Technical Service Information

THM 4L60-E NEW DESIGN 1-2 ACCUMULATOR PISTON

Figure 1
AUTOMATIC TRANSMISSION SERVICE GROUP

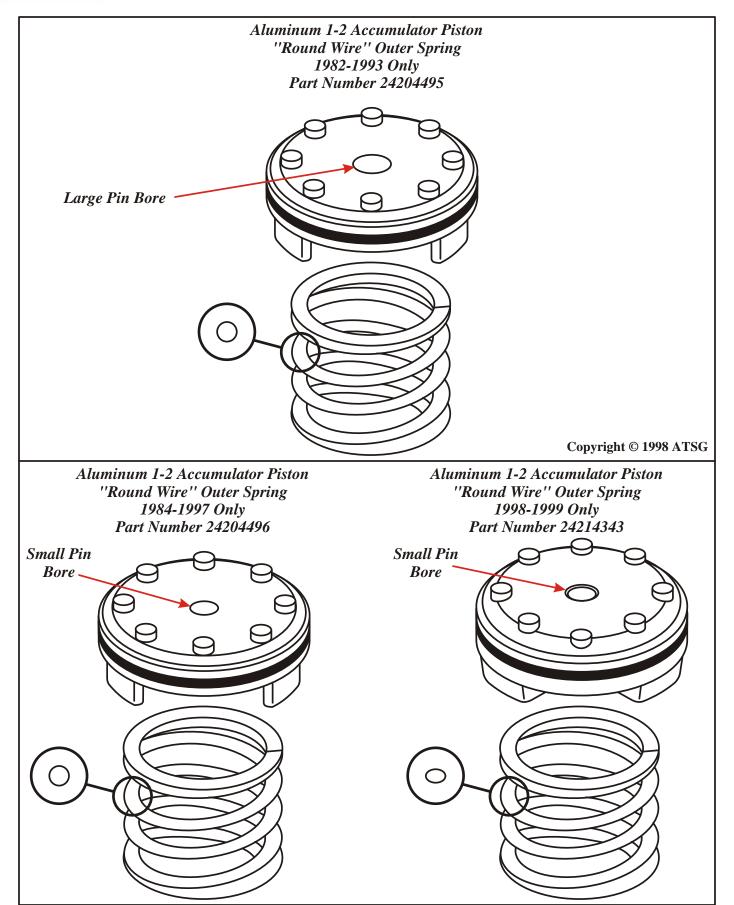
CHANGE: Beginning on May 11, 1998 (Julian Date 131) all THM 4L60-E transmissions were built with a new design plastic 1-2 Accumulator Piston, and an ovate (oval) wire outer accumulator spring, to replace the previous design aluminum piston and round wire outer accumulator spring, as shown in Figure 1.

- (1) 1-2 ACCUMULATOR PISTON Now manufactured out of plastic instead of the previous aluminum, which necessitated a dimensional change, as the plastic piston is thicker as shown in Figure 1.
- (2) 1-2 ACCUMULATOR OUTER SPRING Now manufactured out of an ovate (oval) wire instead of the previous design round wire, to eliminate coil bind as shown in Figure 1.

The different 1-2 Accumulator Pistons and Outer Springs are not interchangeable. When replacing these parts you must remove the 1-2 Accumulator Assembly and inspect for the presence of either the aluminum or plastic 1-2 accumulator piston.

The plastic piston must use the ovate wire outer spring, and the aluminum piston must use the round wire outer spring to ensure against coil bind and spring breakage.
